Goodfellowship / Morgan Park
 Community Club
 City of Duluth, MN

2013

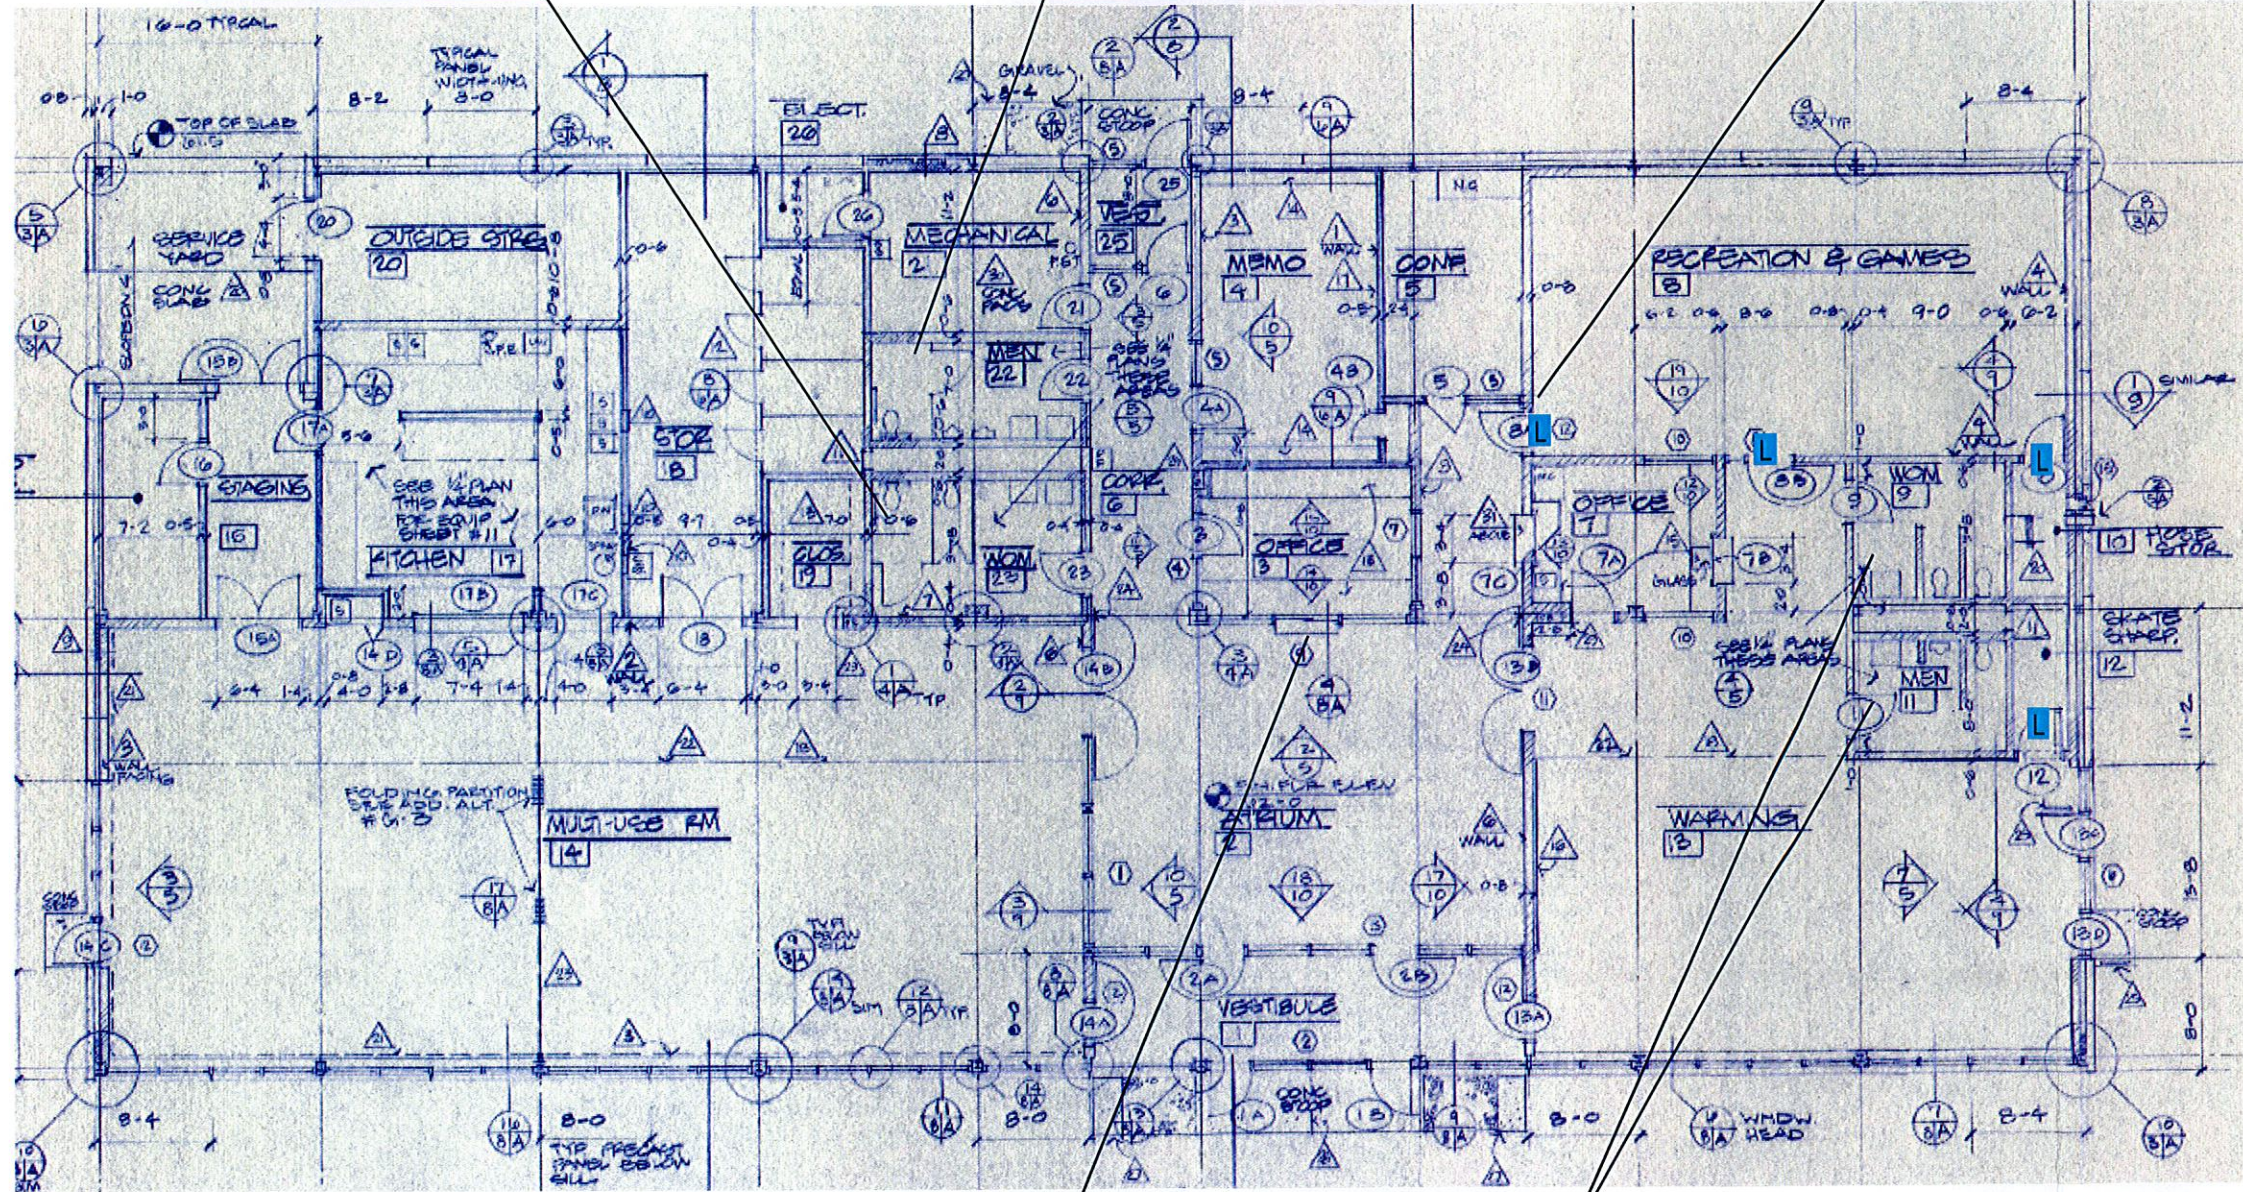
Add raised and braille sign
 Create 60" accessible stall
 Replace grab bars
 Relocate toilet paper dispenser
 Add pulls to accessible stall door
 Replace stall door lock
 Add a low coat hook
 Insulate pipes at lavatory
 Replace faucet hardware
 Add full height mirror

Add raised and braille sign
 Create 60" accessible stall
 Replace grab bars
 Relocate toilet paper dispenser
 Add pulls to accessible stall door
 Replace stall door lock
 Add a low coat hook
 Insulate pipes at lavatory
 Add full height mirror
 Re-hinge the entry door
 Lower the urinal

Add raised and braille sign
 Relocate bench

⌊ Install door lever hardware

Parking
 Re-stripe to provide 8' wide aisle
 Relocate the parking sign

Lower a section of counter to 36" max.

Add raised and braille sign
